Response to Submissions and Amendments to Proposed Development

Former Royal Rehabilitation Centre Sydney, Ryde Amended Stage 2 Layout

Submitted to Department of Planning and Environment
On Behalf of Frasers Putney Pty Ltd

May 2014 ■ 13262

Figure 6 – Proposed building layout and setbacks

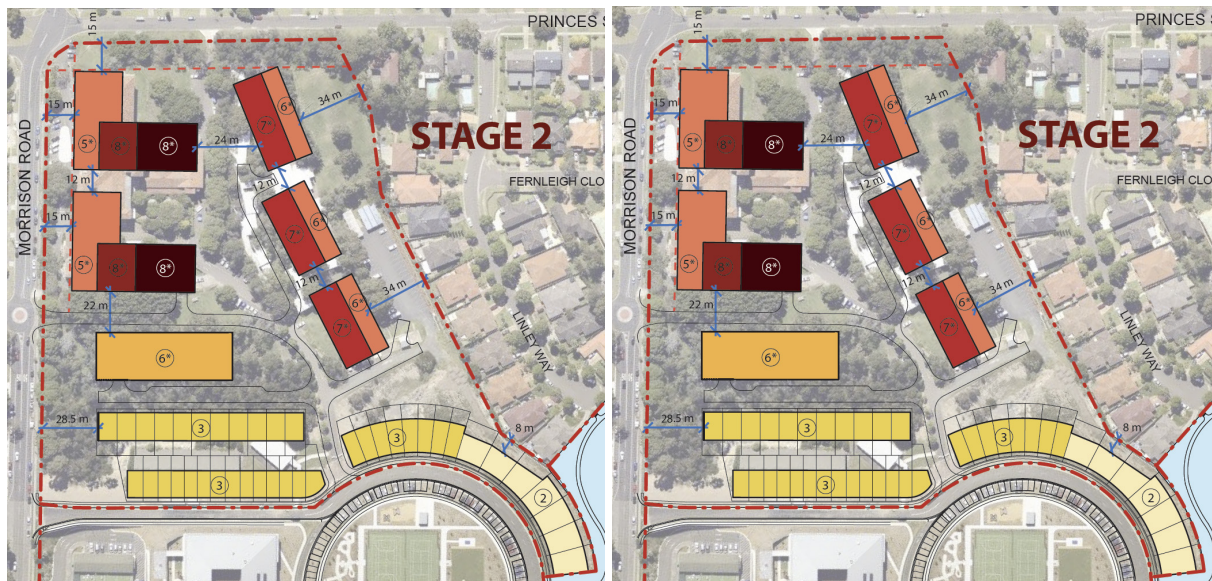
Council did not raise any objection to the height of buildings, but suggested that the setbacks to Morrison Road and Princes Street be more closely reviewed. Council also acknowledged that the future buildings were likely to be well designed, but requested that additional controls be included in the Concept Plan to secure the achievement of well-designed buildings.

The two 'L' shaped buildings fronting Morrison Road have been setback further from the layout originally proposed in the exhibited modification application. The predominant building line is now setback a minimum of 15 metres from Morrison Road, compared to the exhibited setback of 10 metres. This setback is the maximum which can be achieved for these buildings considering the topography of the site and the objective of retaining more significant existing trees. The topography drops sharply from these buildings when moved further within the site. As set out in **Section 3.2.3** below, the maximum height of the two 'L' shaped buildings has been increased in part to account for the greater building height where the site begins to dramatically slope.

The positioning of building envelopes and subsequent setbacks to Morrison Road and Princes Street has been amended in light of comments made during the public exhibition period. The setbacks to Morrison Road and Princes Street have been increased from the exhibited modification application to a minimum of 15 metres (increased from 10 metres).

Figure 1 – Comparison of exhibited and proposed building height plan

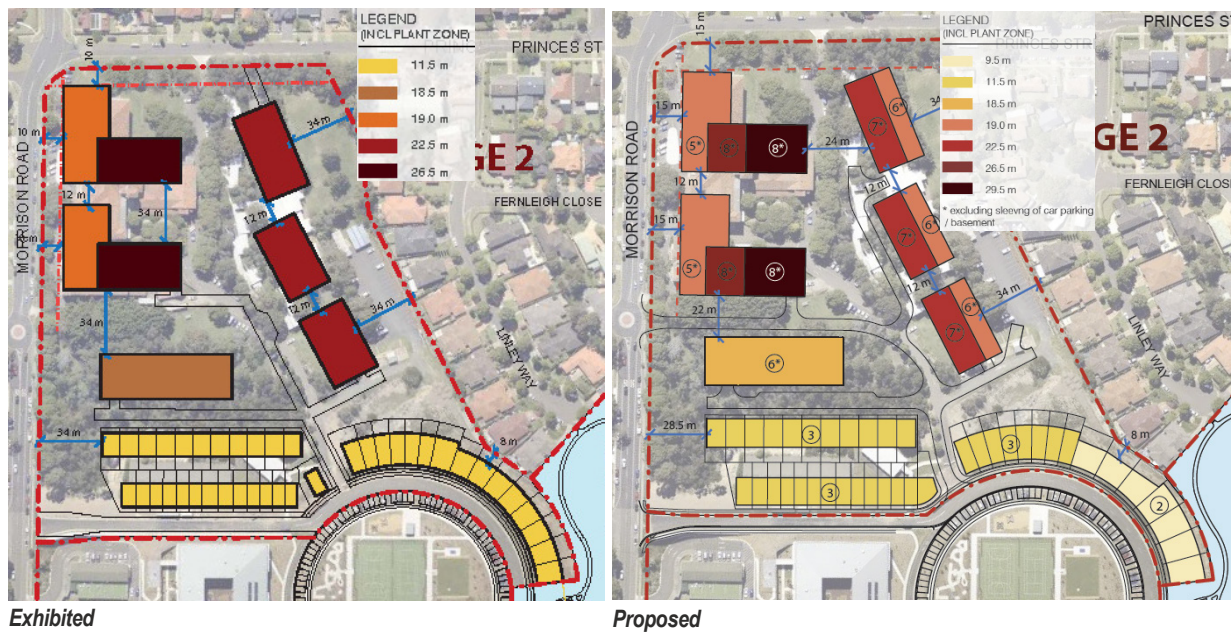
The Department has raised concern that the height of the buildings fronting Linley Way may cause adverse visual impacts, in turn affecting the amenity and character of the surrounding area. It has been suggested by the Department that consideration be provided to the following points:

- Reducing the height of buildings fronting Linley Way, particularly the façades presenting to existing residential dwellings;
- Incorporating design excellence requirements into the Concept Plan Approval for buildings fronting Morrison Road; and
- Amending the street setbacks for buildings fronting Morrison Road.

In direct response to submissions received during the public exhibition period, the maximum heights of the apartment buildings fronting Linley Way have been decreased. A stepped built form is now adopted for these three apartment buildings, with the façade closest to existing residential dwellings lowered to minimise the presence of the buildings.

An increase in height has been proposed on the interior section of the 'L' shaped buildings fronting Morrison Road. This has arisen from shifting the buildings further into the site, as requested by both the Department and Council and therefore directly responds to the site's topography which drops off at this point. It is emphasised that the maximum RL will not be modified. The increase in building height results from the slope of the site and maintaining a consistent overall height for the building. Further, these height increases are located within the central portion of the Stage 2 site and represent the areas furthest away from established residential areas surrounding the site.

Furthermore, the increased height will not result in a greater number of whole residential levels. Where the greater building height is proposed, residential apartments will be provided at the ground level to screen the increased basement car parking protrusion.

Figure 2 – Comparison of exhibited and proposed street layout

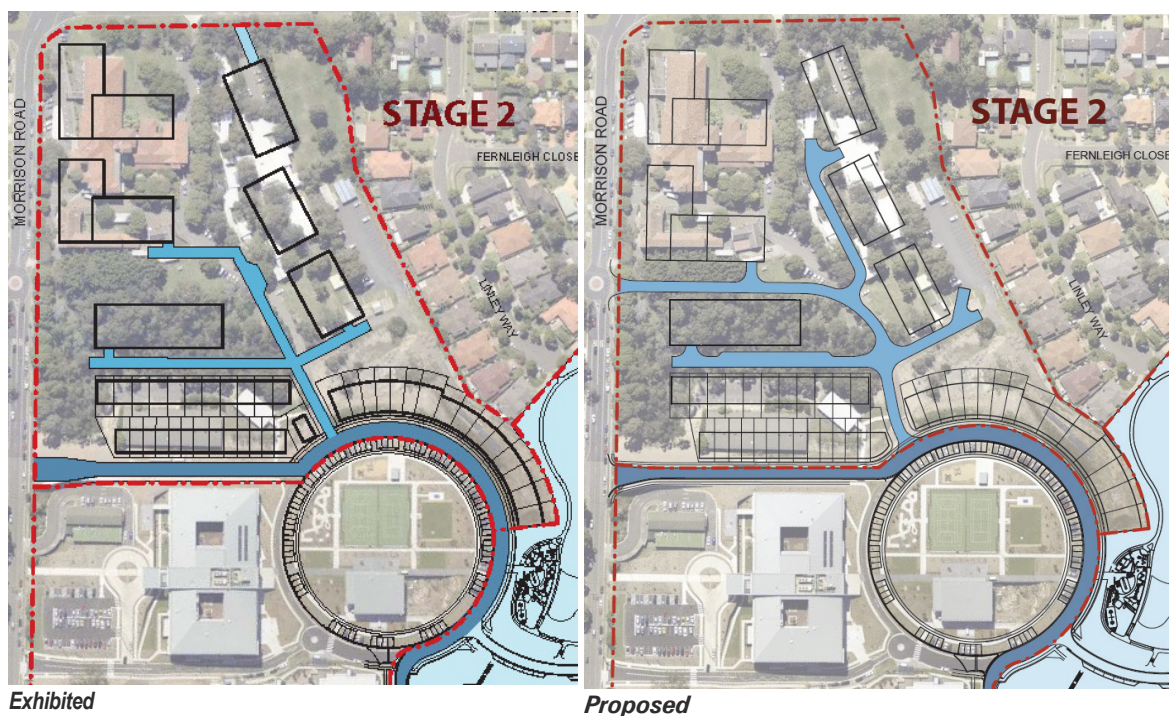
RRCS has suggested that an additional access point should be provided into the Stage 2 site. The Department has reaffirmed this suggestion, requesting that consideration be given to increasing permeability through the site and distributing traffic flows from the site.

In response to comments made during the exhibition period, Frasers Putney has sought to amend the street layout within Stage 2 of the Concept Plan. Concern was raised during the exhibition period on the lack of access into/from the Stage 2 site. As such, an additional access point on Morrison Road is now proposed, providing a more permeable street network. A comparison of the exhibited and proposed street network is illustrated in **Figure 4**.
